The Columbia Architectural Design Review Team will meet on Tuesday, January 17, 2023 at 9:00 AM in Conference Room A on the basement level of City Hall, 700 N. Garden Street. The Planning Commission will consider the following:

City of Columbia
ARCHITECTURAL DESIGN REVIEW TEAM
December 13, 2022

PROJECT DESCRIPTION: 732 Armstrong Lane Building

**PROJECT DESCRIPTION: Façade
Modification**

2500 HOSPITALITY BLVD MINOR EXTERIOR REMODEL

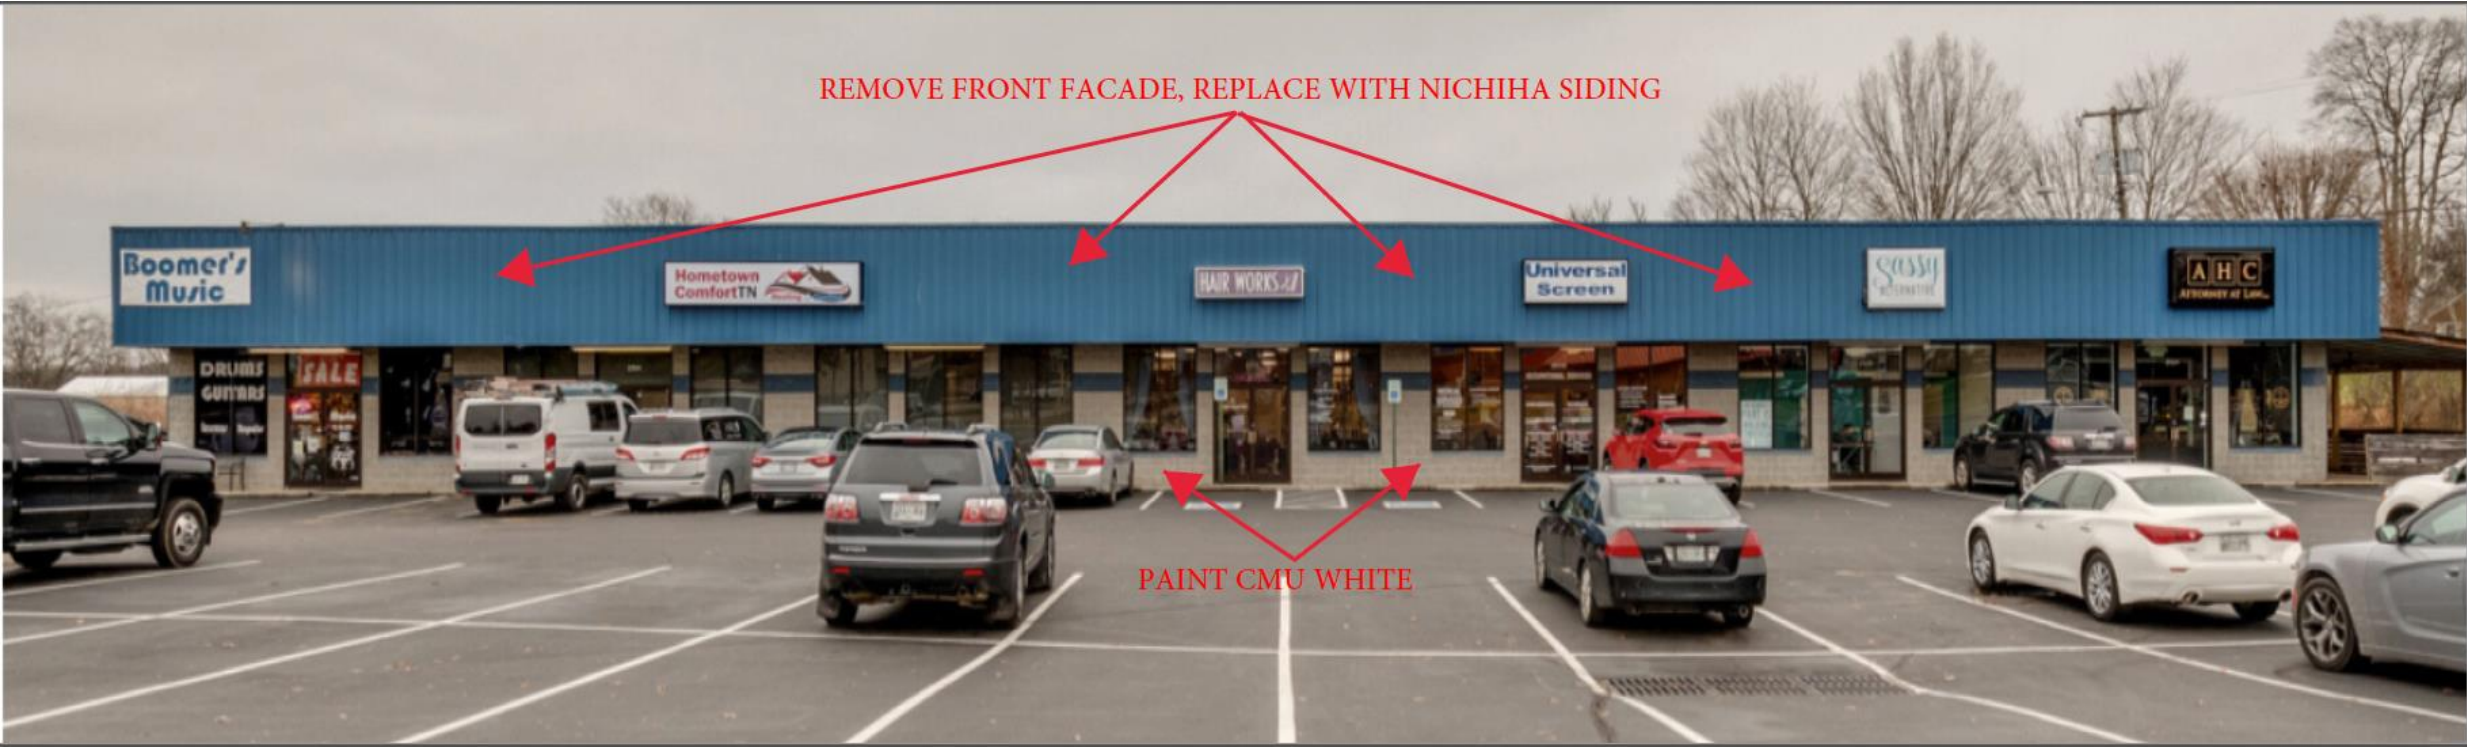
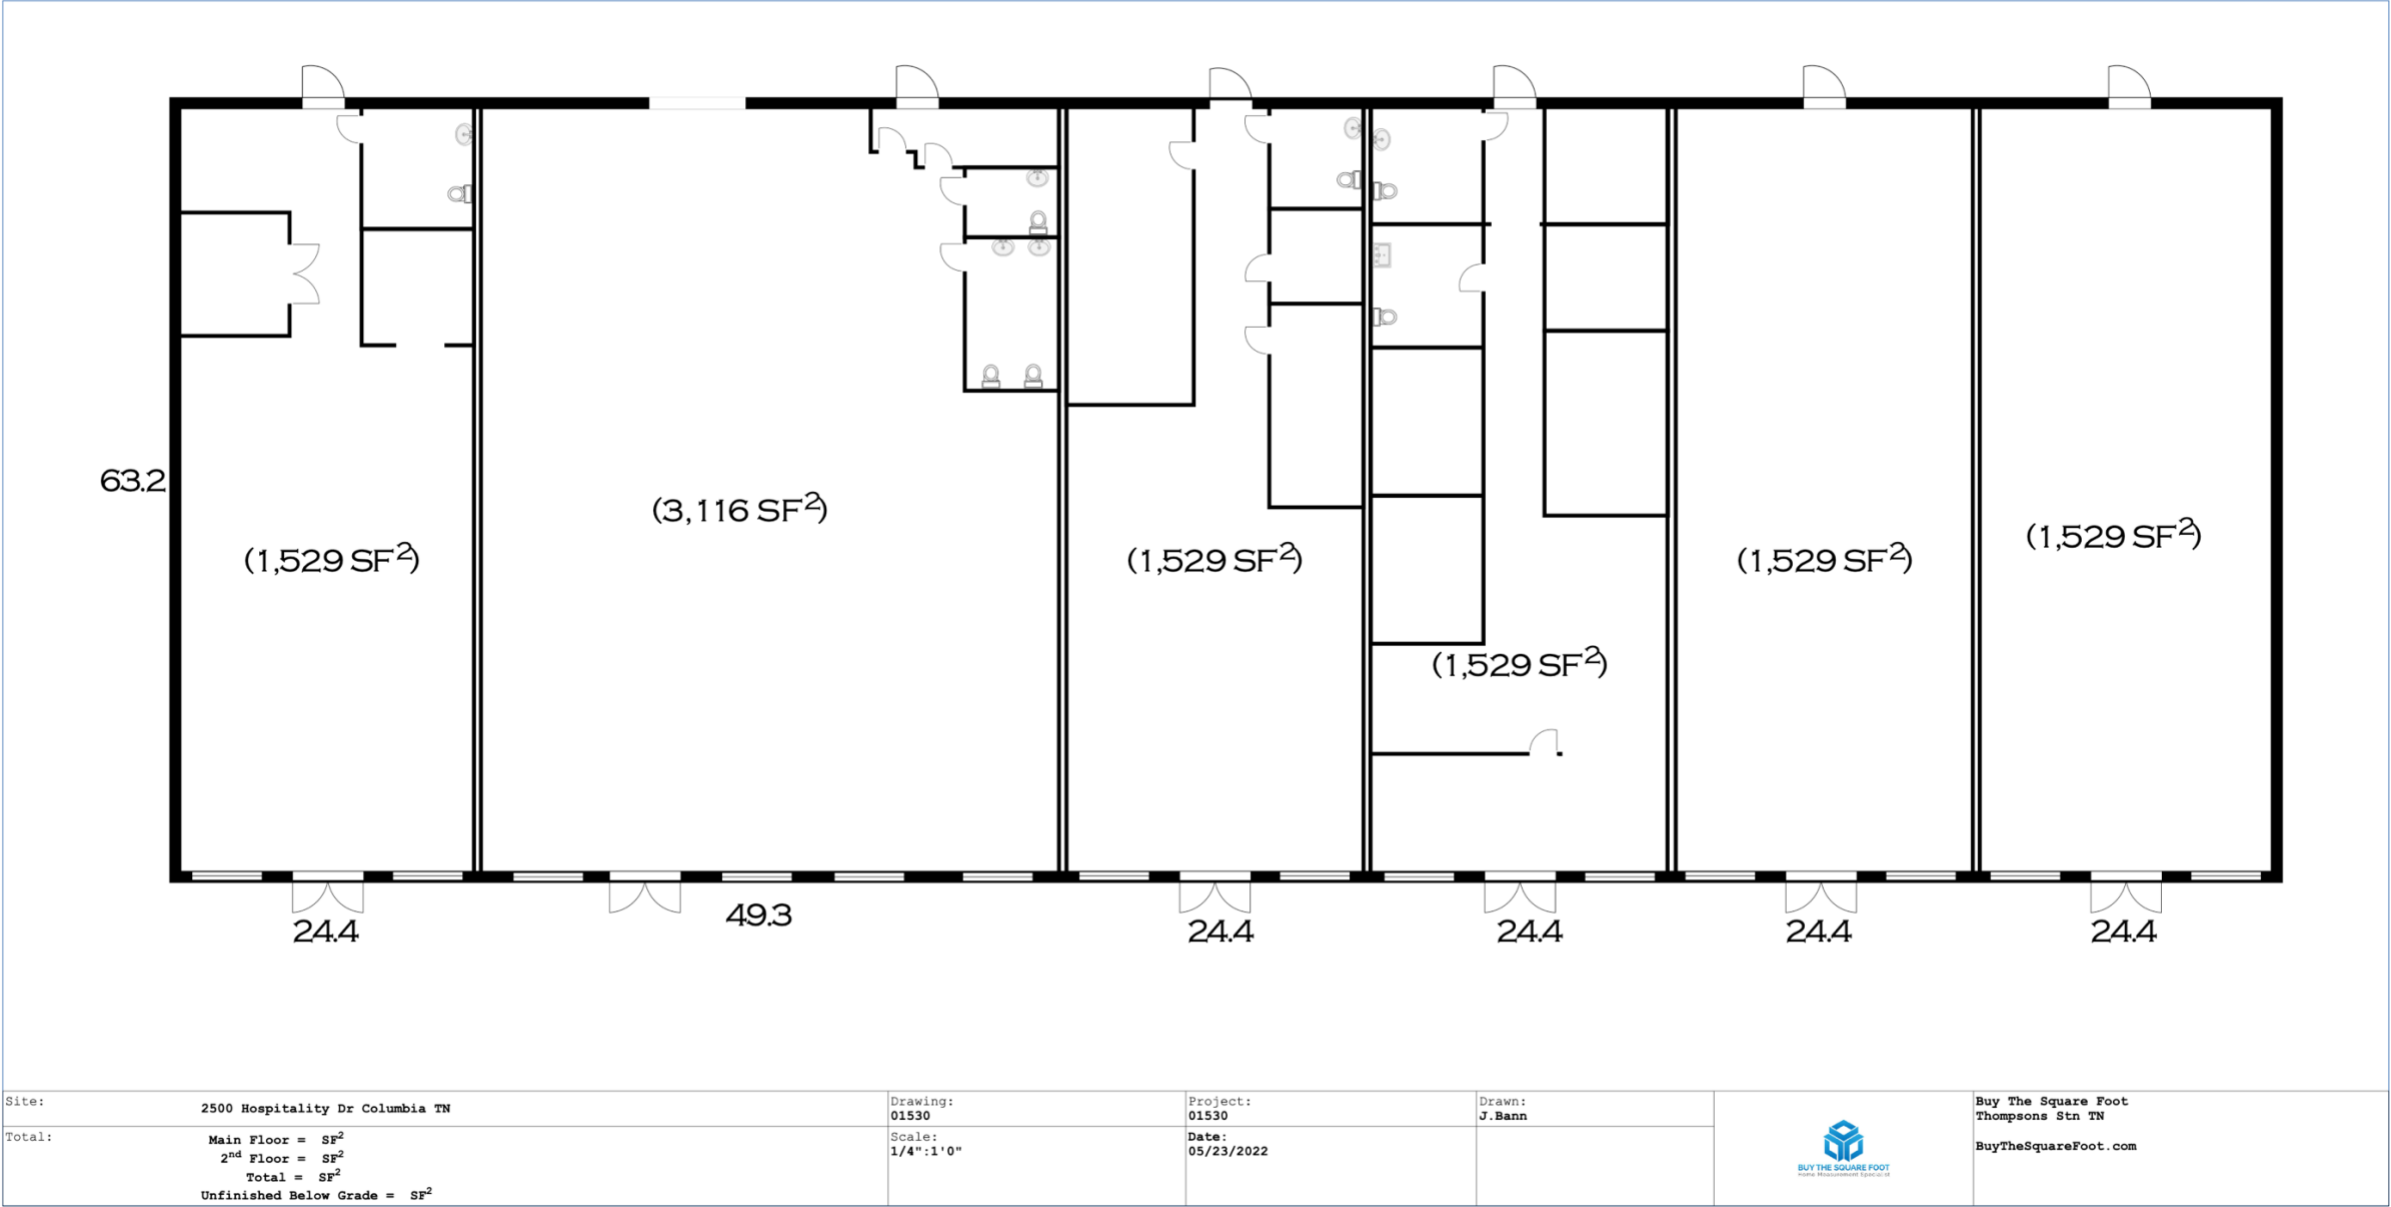
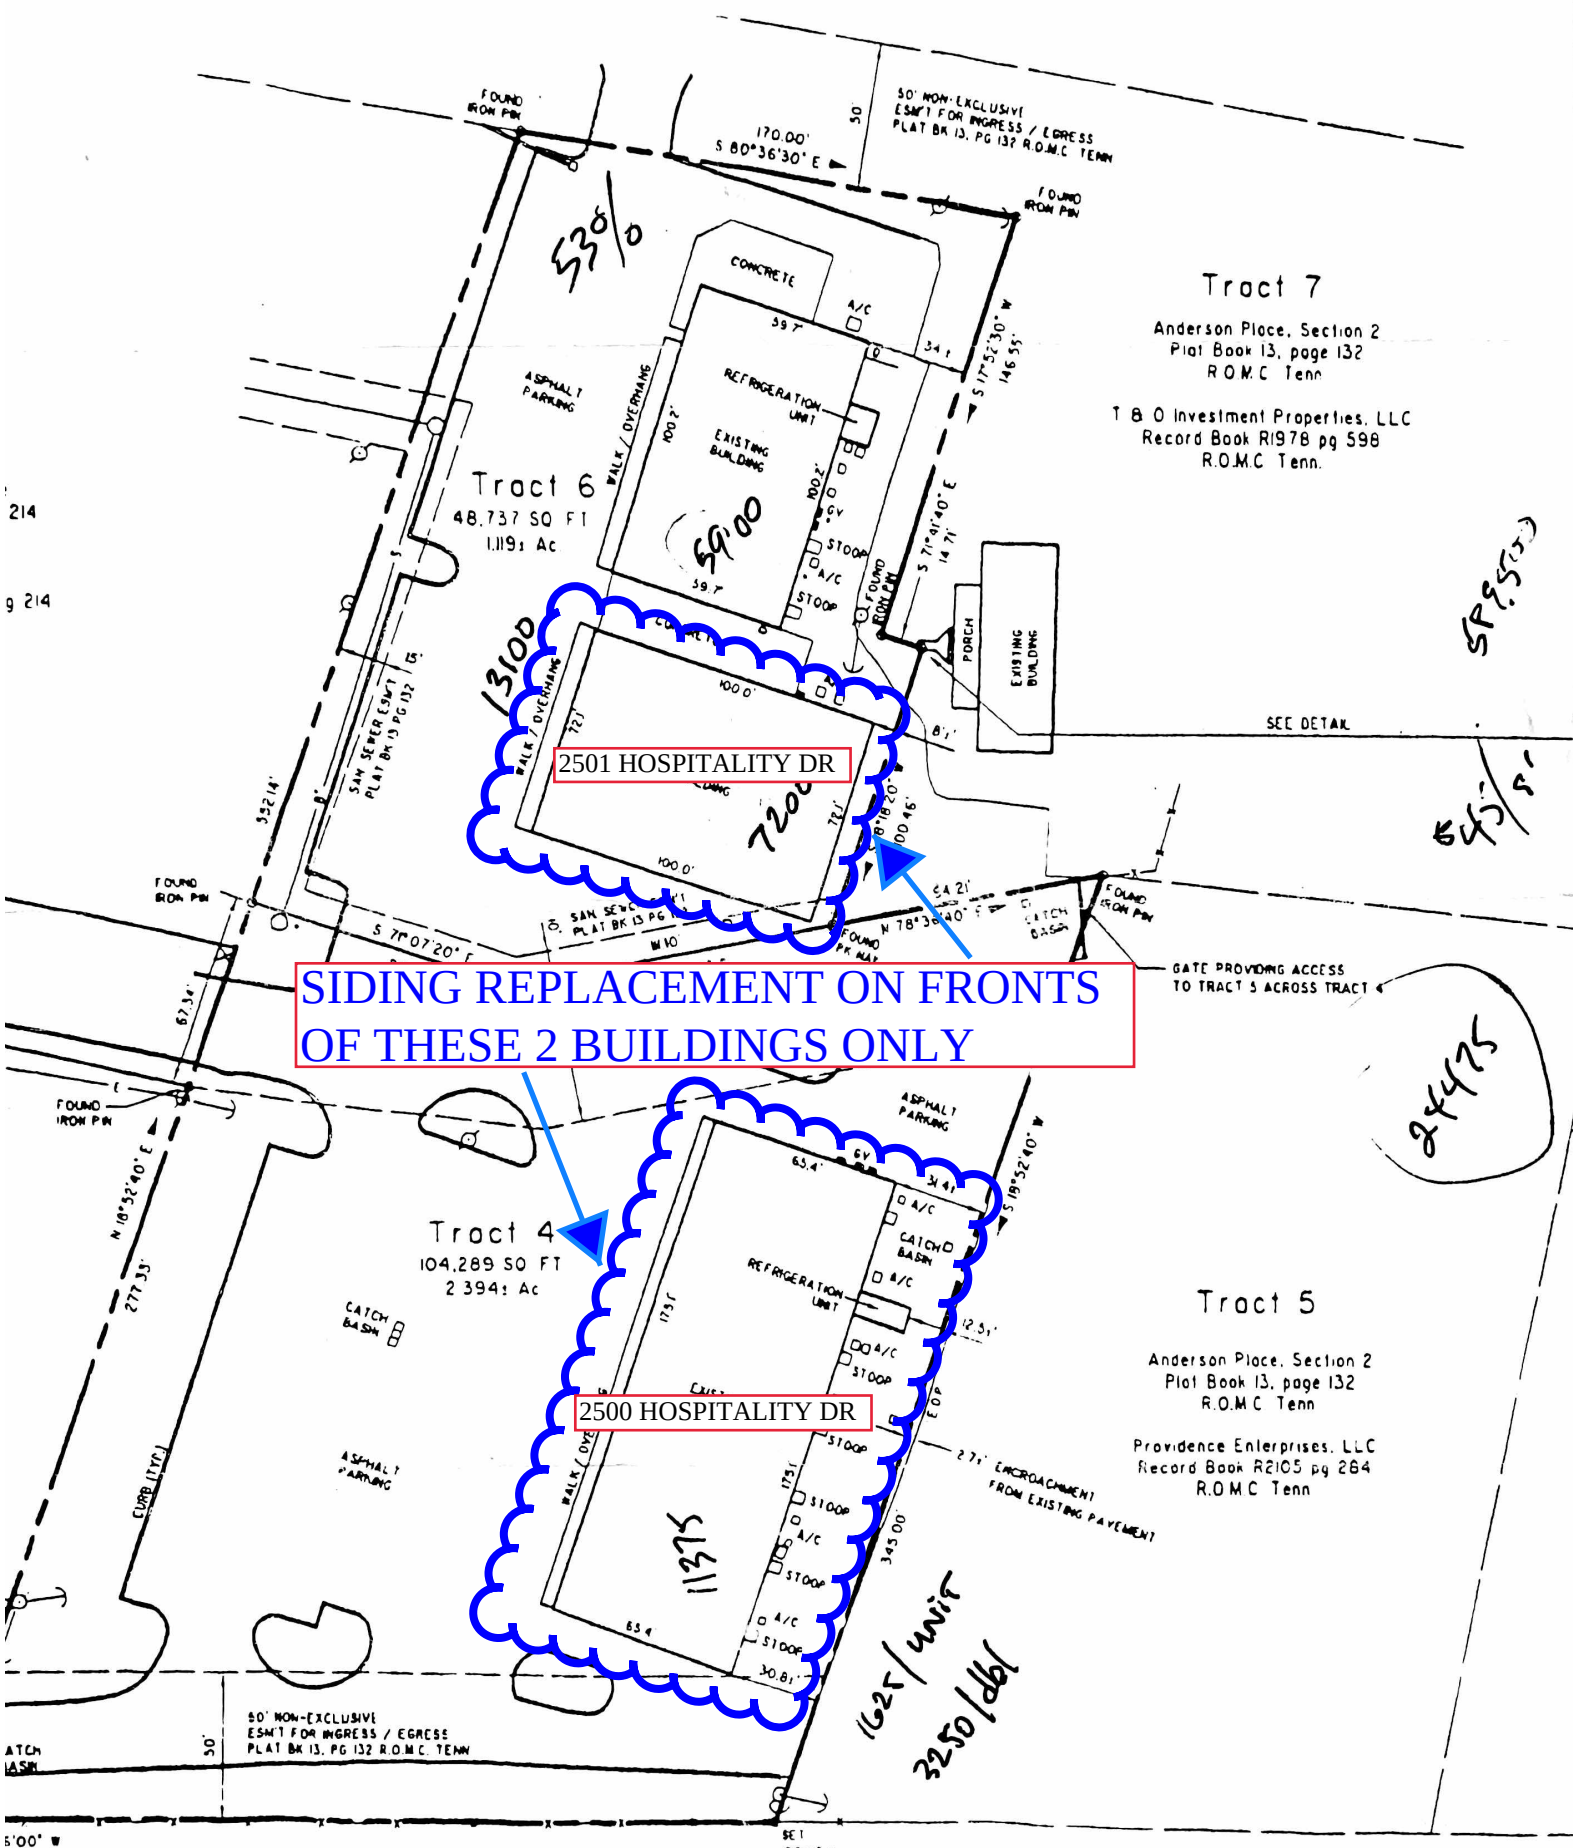
- This façade modifications includes the replacement of non-conforming metal siding to be replaced with NICHHA siding (wood grain fiber cement board siding) on the upper parapet. Wood and cementitious siding is a permitted material in a C-PUD.
